CALIFORNIA COASTAL COMMISSION

September 23, 1999

SUBJECT: Proposed Major Amendment 1-99 to the Pepperdine University
Long Range Development Plan for Public Hearing and Commission Action
at the October 12, 1999 Commission Meeting

EXHIBIT 5
Pepperdine LRDP 1-99
Conceptual Grading Plan

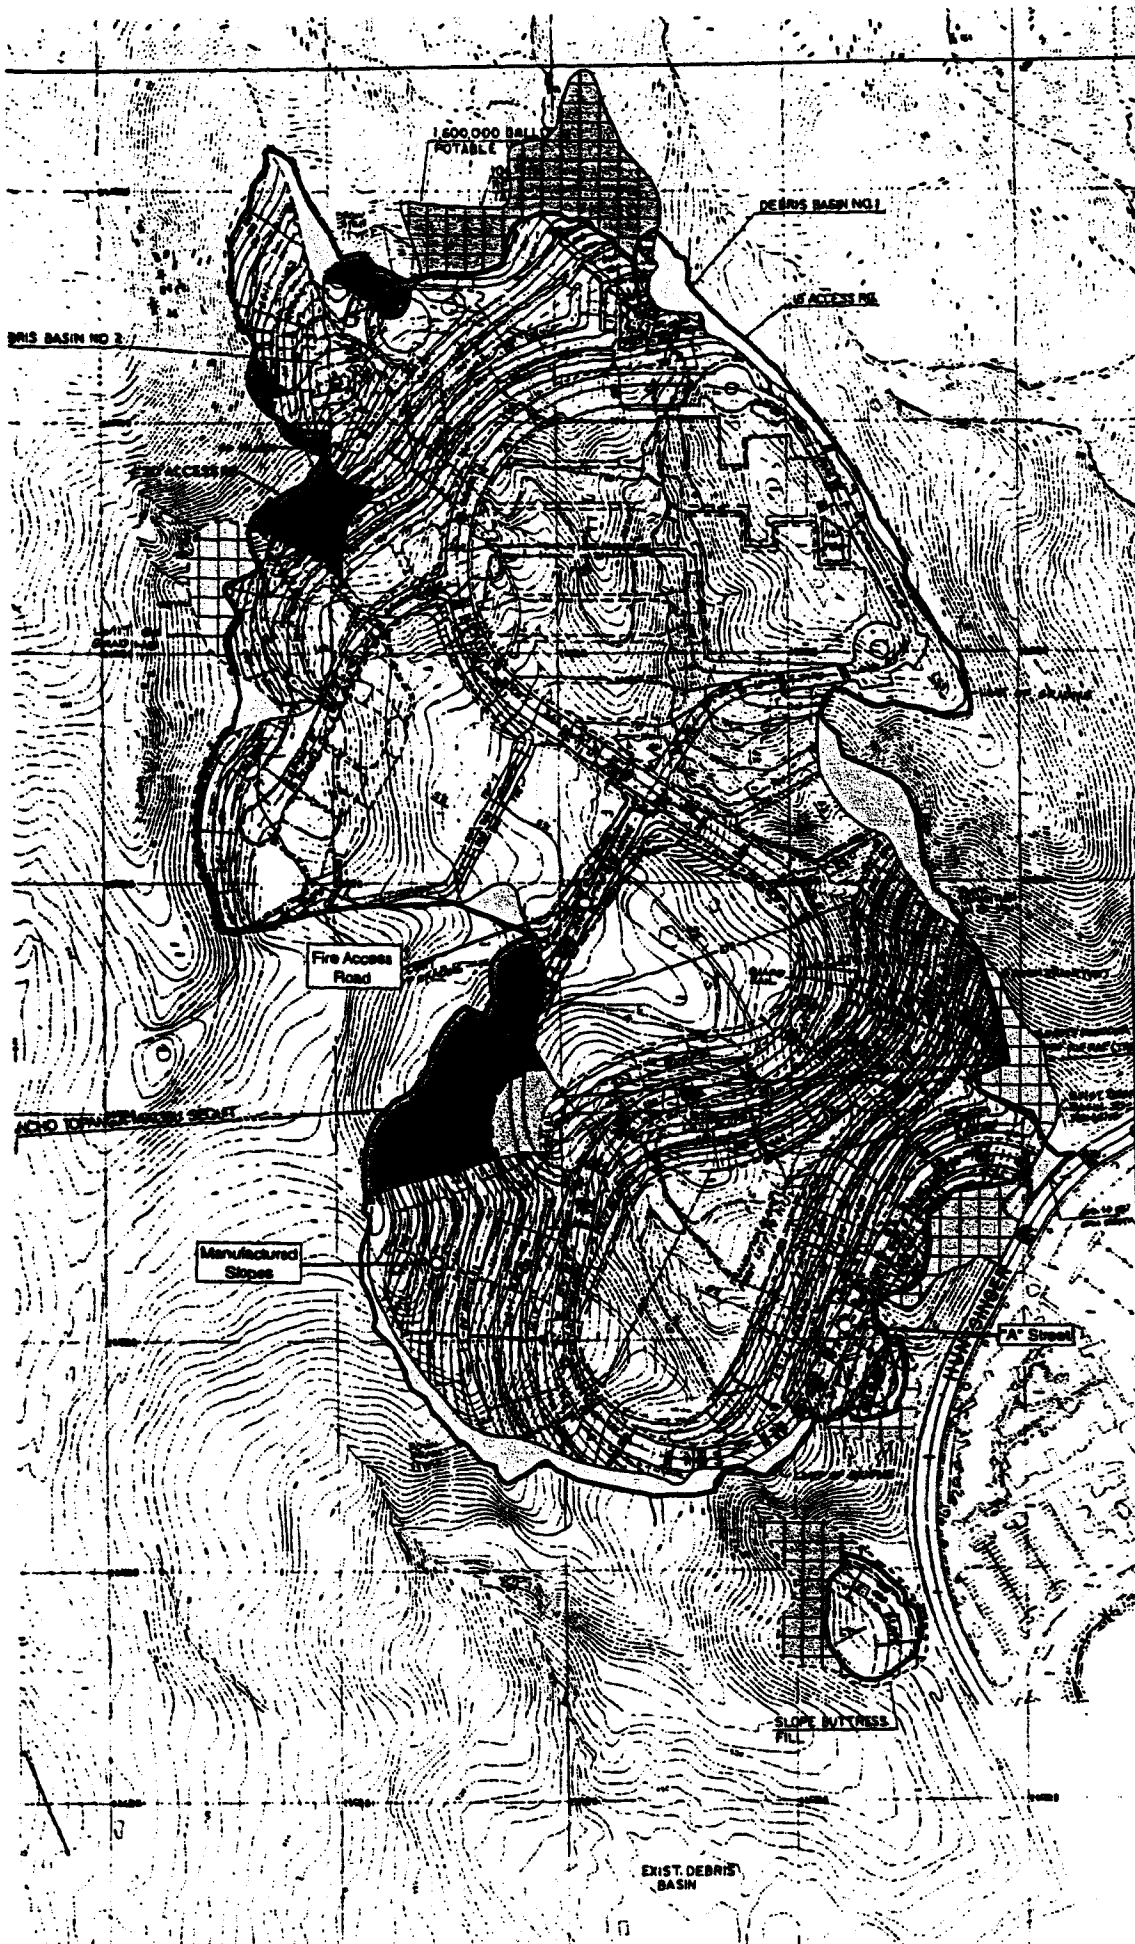
In addition to site stabilization, the 4.5 million cu. yds. of grading proposed for the UCD site includes grading of roads and pads. As shown on the Conceptual Grading Plan (Exhibit 5), several large and small pads would be provided. The northernmost pad is the proposed location of the Graduate Complex, including a seven-level terraced parking lot. The next pad downslope would contain the faculty/staff housing area, with several smaller pads for single family residences and two larger pads for townhouses. The next pad area downslope would be the location of the student housing. Finally, the lowest pad would contain the academic learning center and the academic support facility. The grading plan include a primary access road to serve all the pads, a secondary road that forms a figure "8" with the primary road. The certified LRDP included a primary access road that ended in a cul-de-sac. The Los Angeles County Fire Department would not permit an access road of this length without a secondary form of access. Additionally, roads are provided to the housing areas and to the proposed water tank.

As shown on the Conceptual Grading Plan, manufactured slopes would occupy approximately one-half (25-acres) of the overall area of the UCD site. Pads or level areas would occupy 18.5-acres, and roadways would occupy 6.9-acres. Grading of the UCD site would create a sequence of manufactured slopes, each one supporting a pad area, as described above, upon which development would be located. According to the EIR, the total vertical extent of the successive manufactured slopes would be 530 feet.

The ridgelines on the UCD site would be widened by cutting and the canyons by filling. According to the EIR: "The highest elevations along the northeastern ridgeline are being lowered about 60 feet, and a less prominent northcentral ridgeline is being lowered about 75 feet". The EIR concludes that with regard to landform alteration:

EXHIBIT 7
Pepperdine LRDPA 1-99
Habitat Map

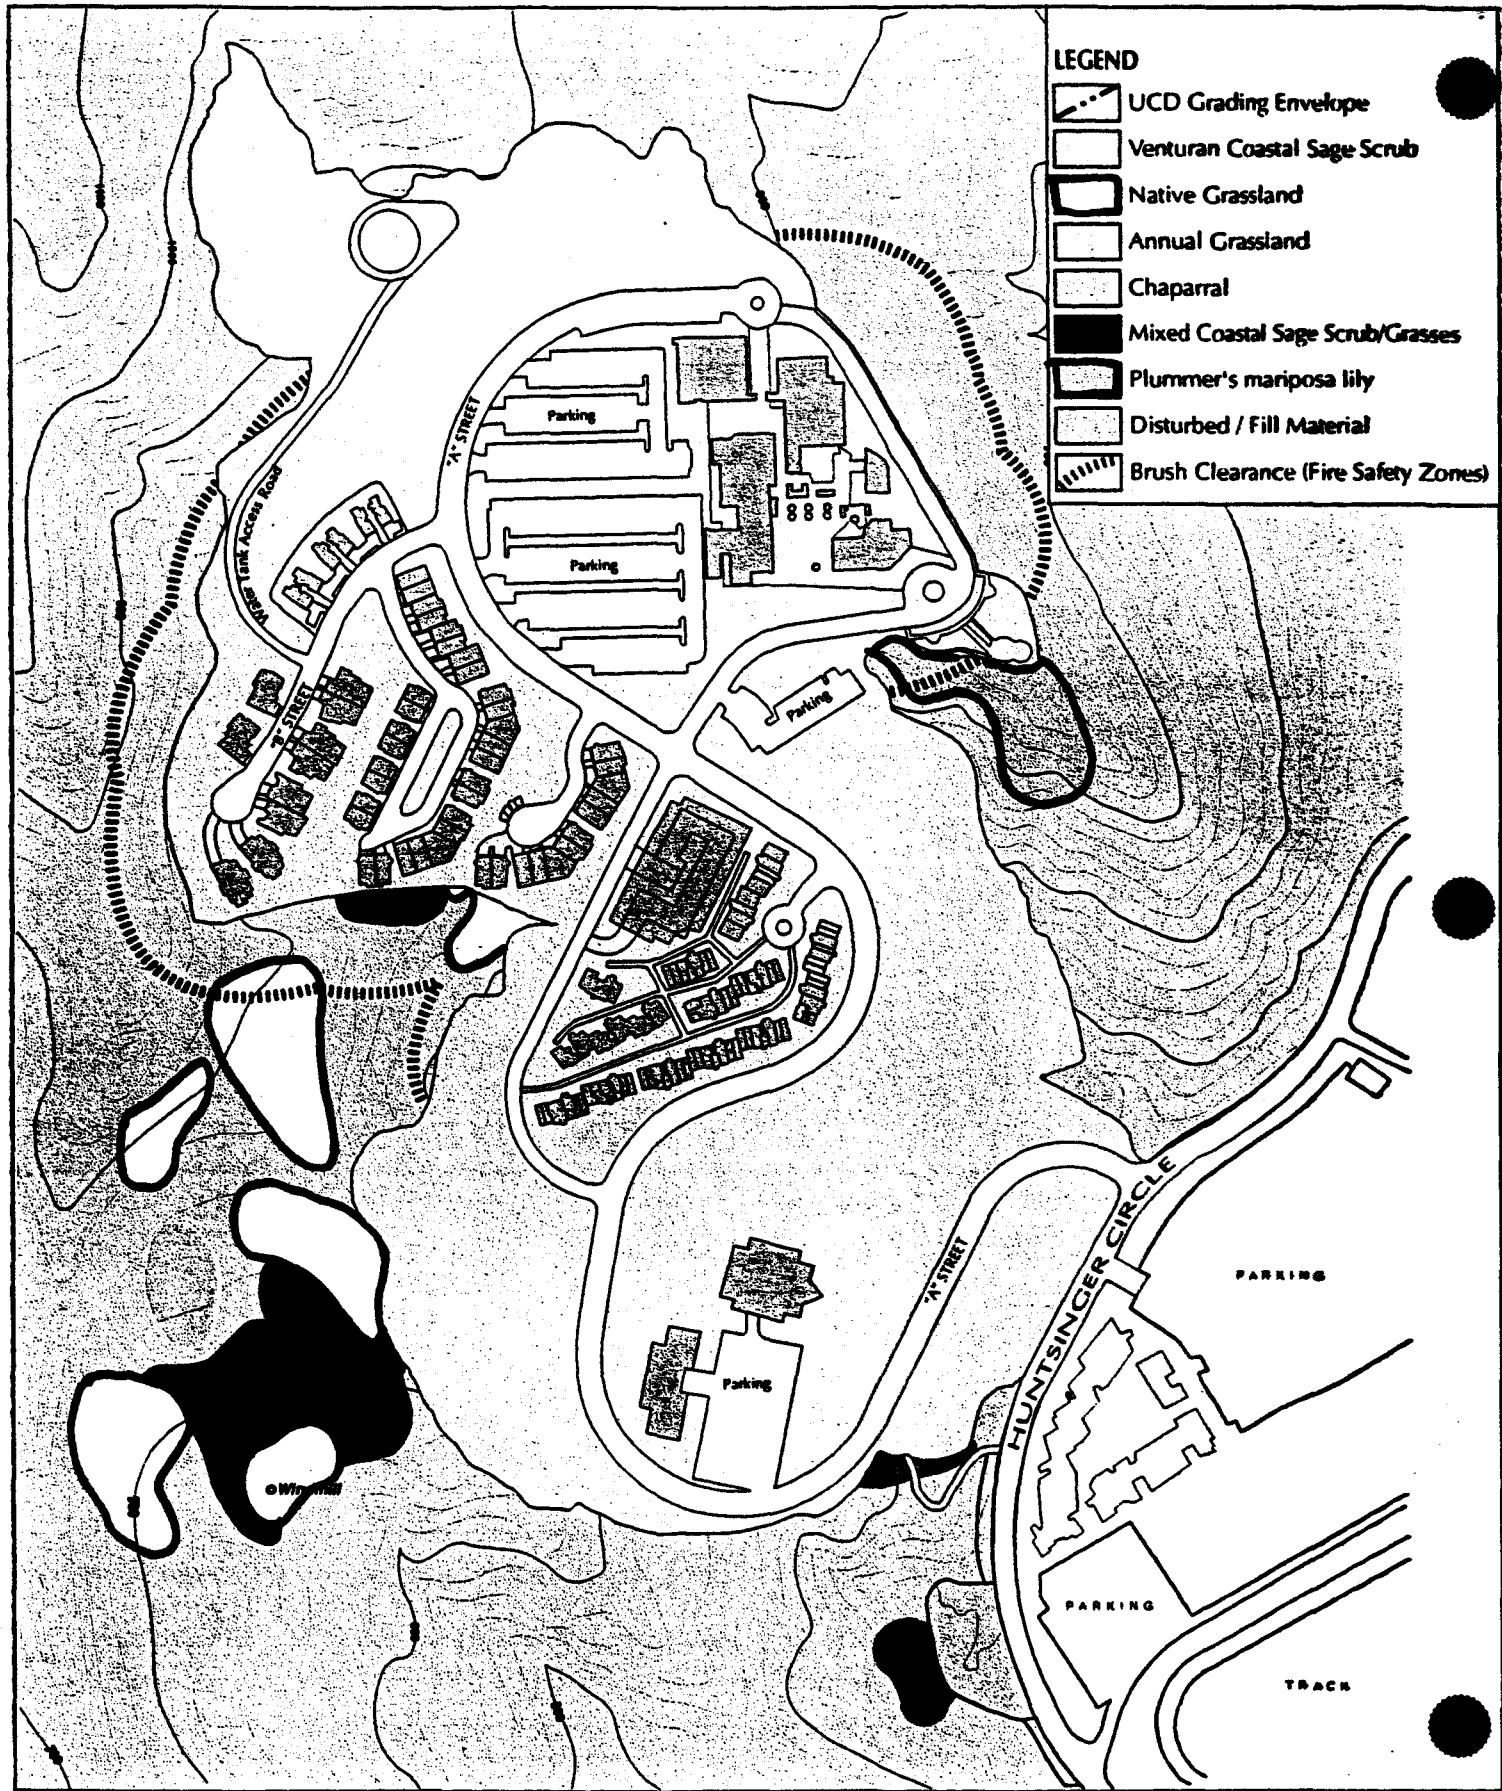
The identified habitat areas are shown on Exhibit 7. As explained in the EIR, "while the plant communities may be well-defined in some places, the vegetation associations tend to overlap considerably on the site. In this way, areas may contain elements of different communities. However, the dominant plant species in each area were designated for the purposes of mapping the plant communities, as shown on Exhibit 7. Following is an acreage breakdown of the habitat types identified on the UCD site:

The Plummer's mariposa lily is the only plant of the four that was found in such a concentrated distribution that it could be mapped. The areas where this plant was identified are shown on Exhibit 7.
